MERCUISER SERVICE BULLETIN

Section: XII (Service
Bulletins)
Number: B 63-12
Date : 8/19/63

- A. Engine Repair Stand for MerCruiser I & II Gasoline Engines
- B. Engine Coupling Assembly Lubrication
- C. Special Fuel Tanks - Cautions

B. ENGINE COUPLING ASSEMBLY LUBRICATION

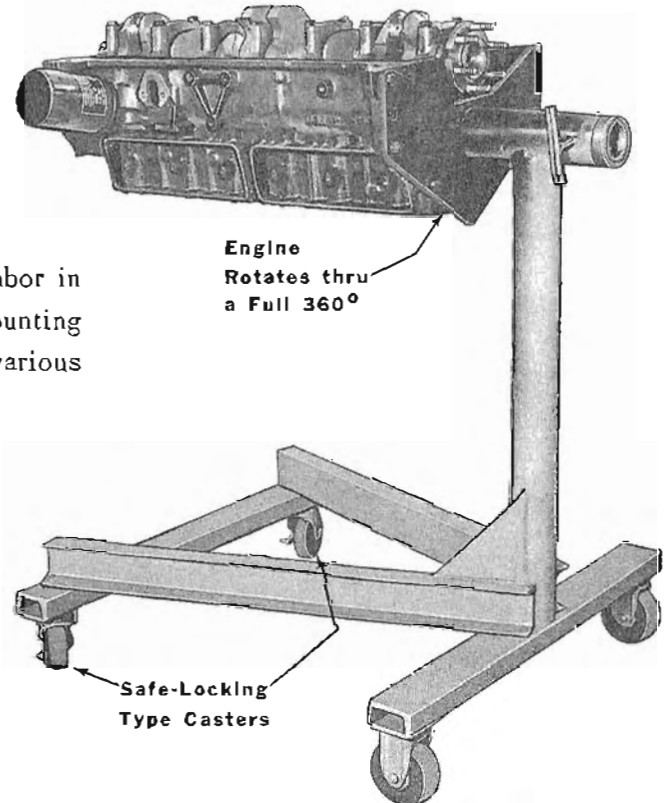
On initial installation and whenever a stern drive unit is removed, it is recommended that the engine coupling splines and drive shaft splines be lubricated with MULTIPURPOSE Lubricant.
